**Broadlands Water Booster Pumping Station
Phase III Upgrade
Project ID Number 2007-0164
RFQ 2011-018-200**

ADDENDUM 1

Addendum Issued: January 26, 2012

PROJECT: Broadlands Water Booster Pumping Station Phase III Upgrade
Project ID Number 2007-0164
RFQ 2011-018-200

PRESSURE RELIEF VALVE
DETAIL 1
NTS M2

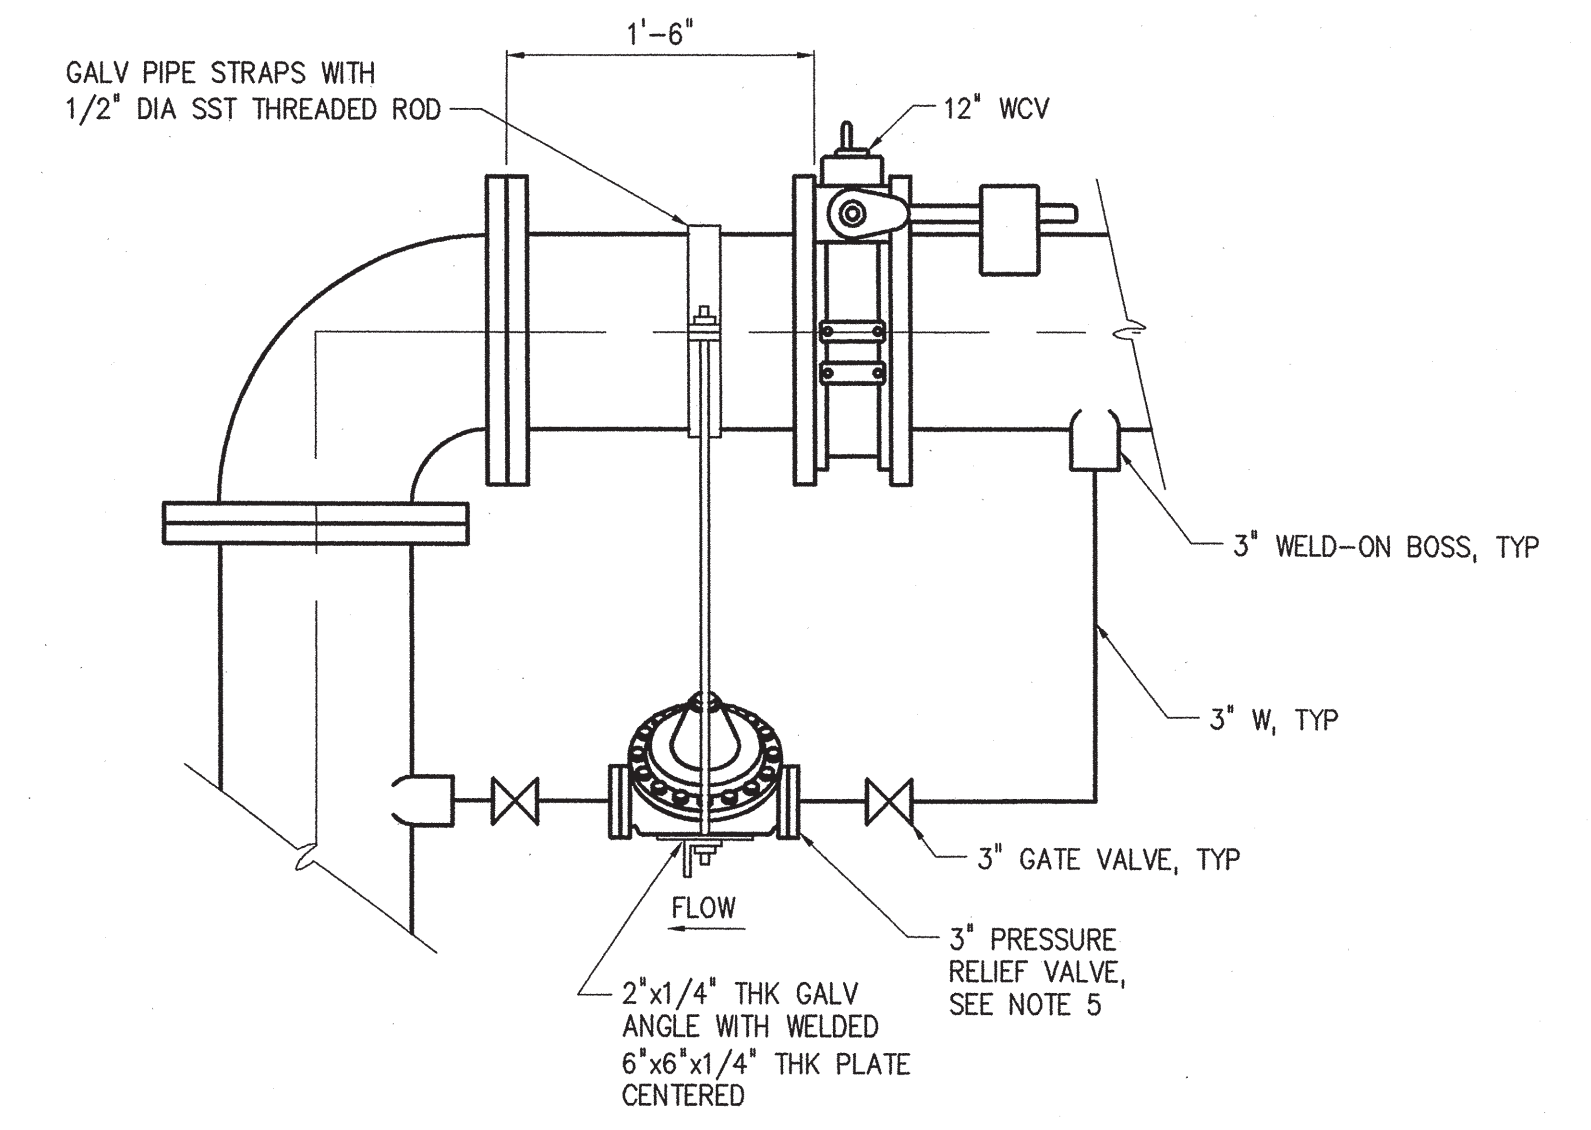
Question 1: Drawing Sheet no. 2 of 7 is missing in the file we downloaded off of the Loudoun Water site. Please provide this missing sheet.

See Attachment #4, Sheet No. 2. M2 - is provided for reference purposes only as no work is shown on this sheet.

Attachment #5 Existing Pump Dimensions

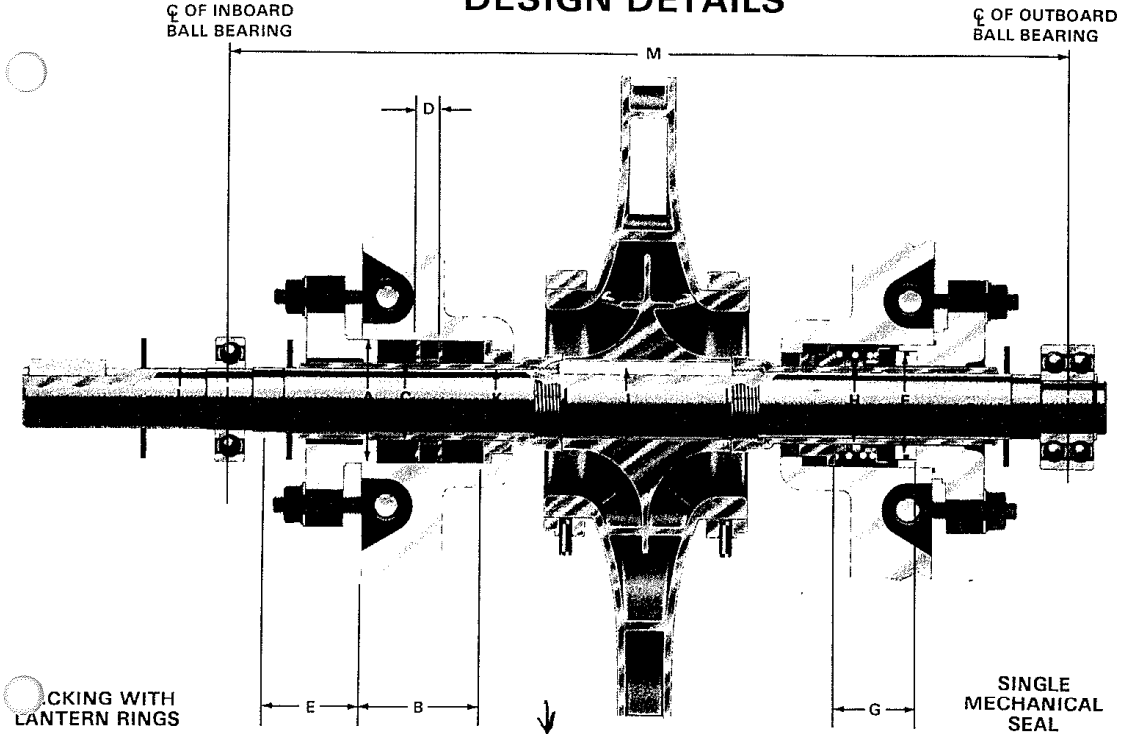
Question 4: Please provide a dimensional drawing of the existing pumps.

Shop drawing of existing pump provided. See Attachment #5.
